ADDENDUM NO. 1

FEBRUARY 22, 2018

MUHLBERG SCHOOL DISTRICT  
FACILITY SECURITY UPGRADES

AM-403

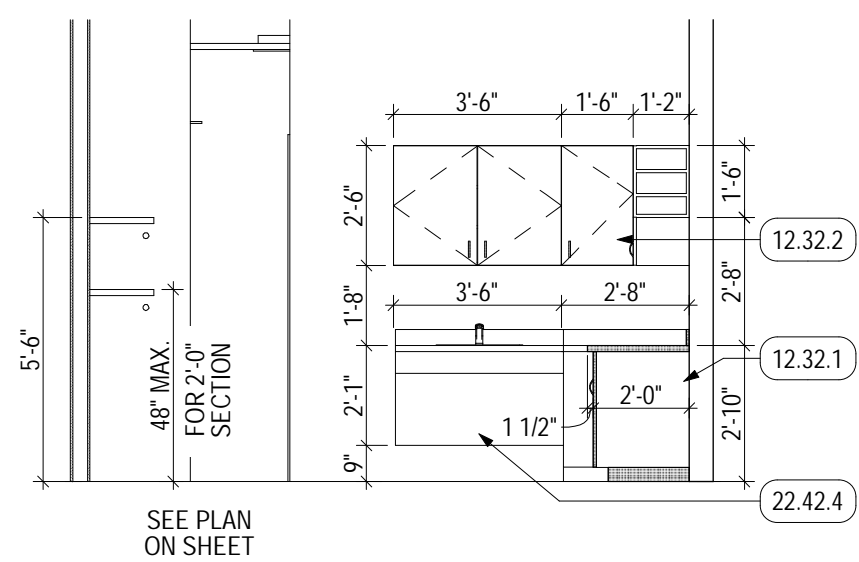
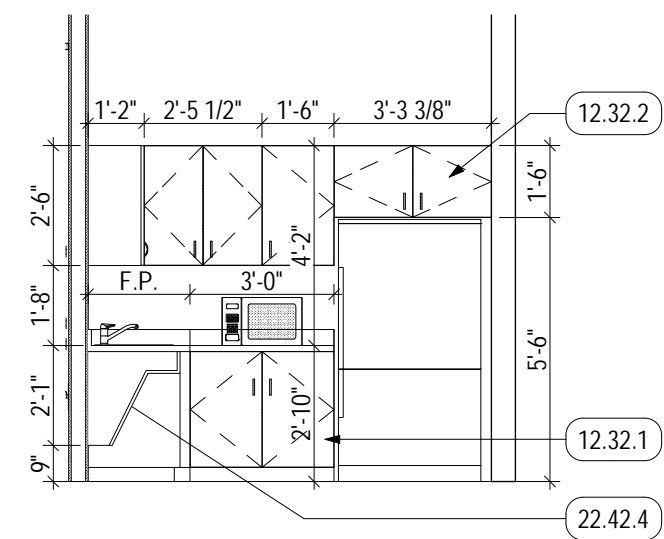
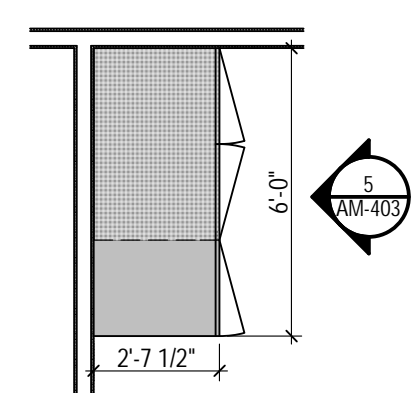
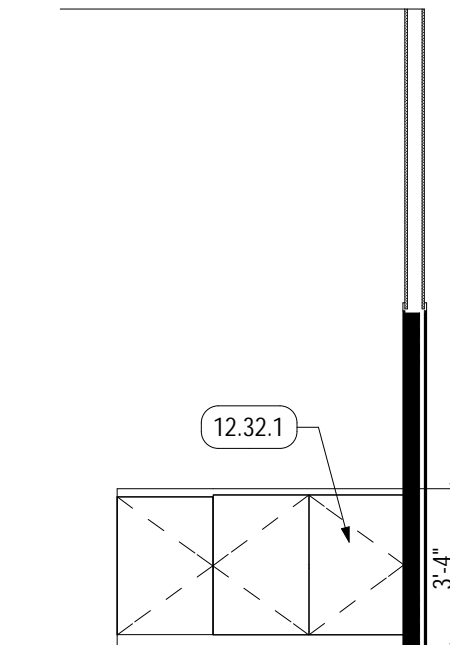
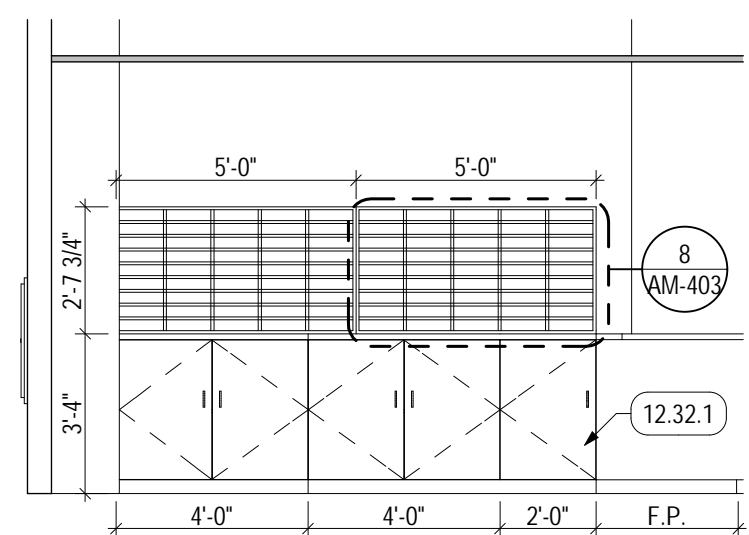
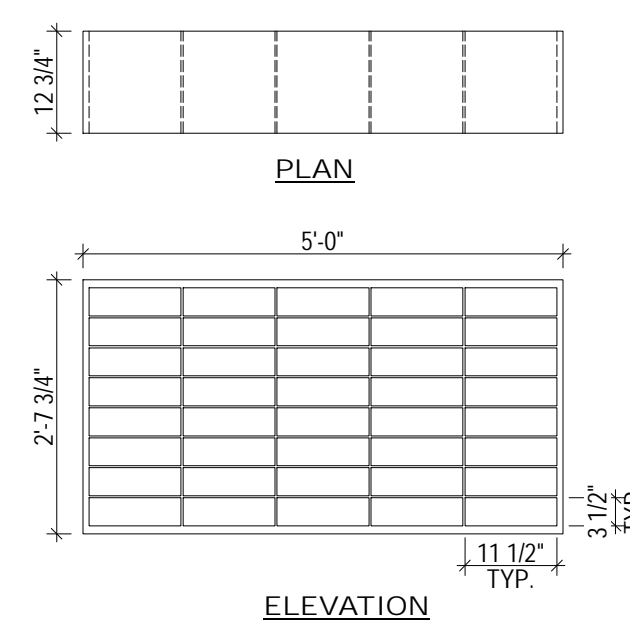
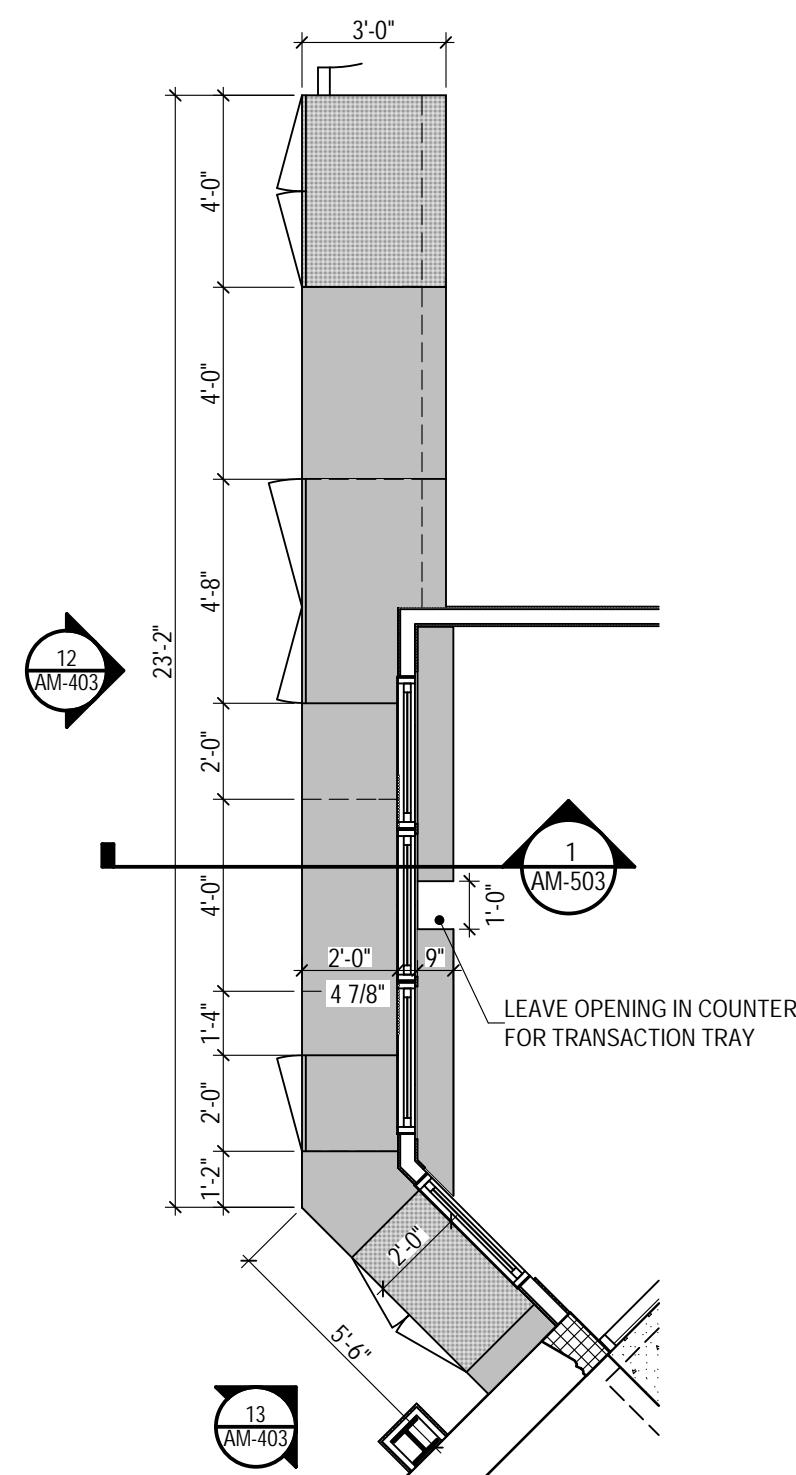
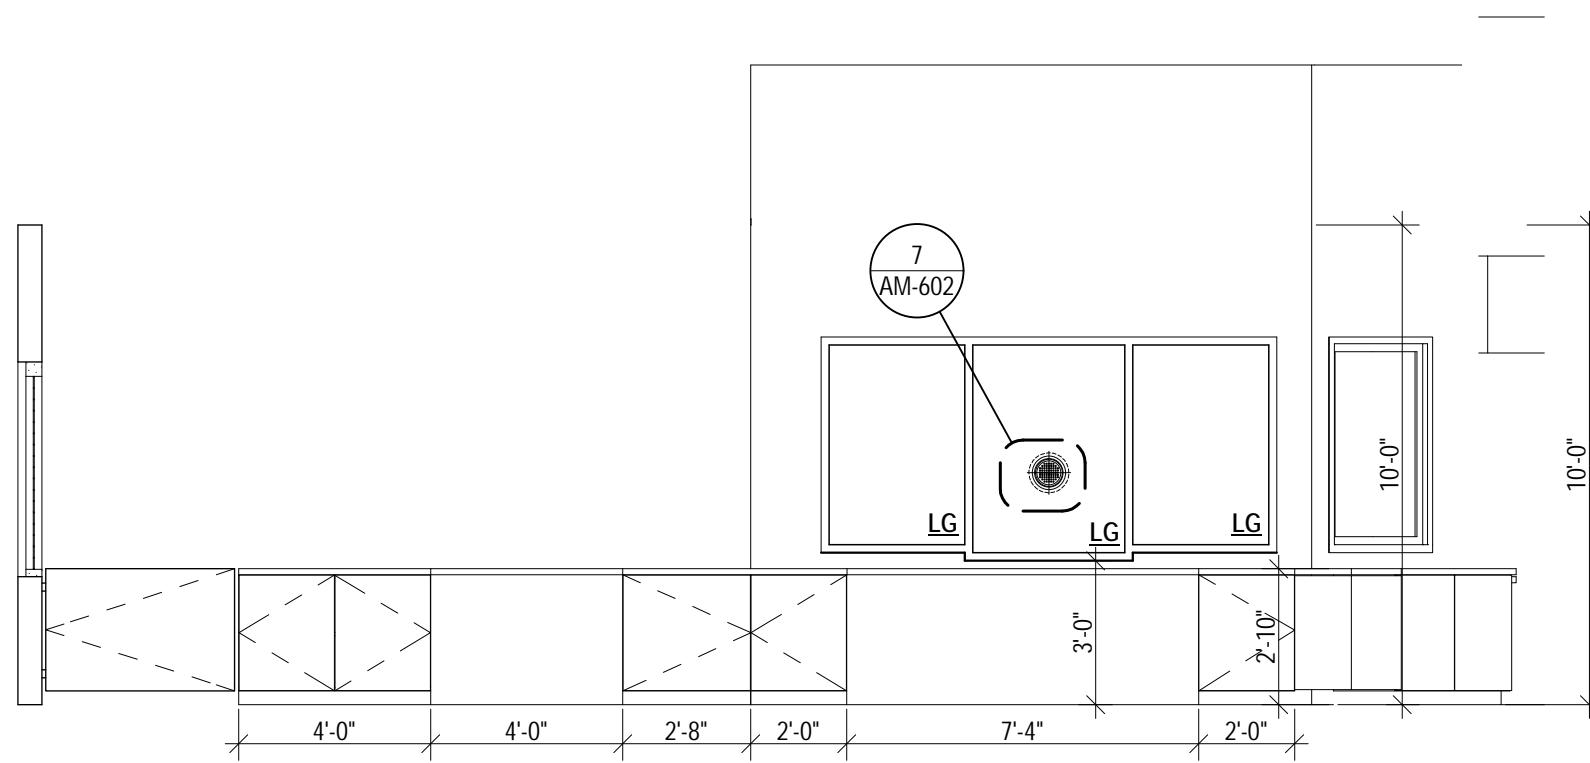
1. **Drawing AH-601**: Doors EX103, EX104, and EX105 are to receive hardware set #31. Door EX106 is to receive Hardware Set #32.
2. **Drawing AH-702**: The floor in Room E113, Vault, is to remain unfinished
3. **Drawing AM-403**: PDF file submitted with original bid package was corrupted. The file has been fixed and is attached to and made a part of this Addendum.
4. **Drawing AM-702**: Room 131A.9 is to receive carpet.
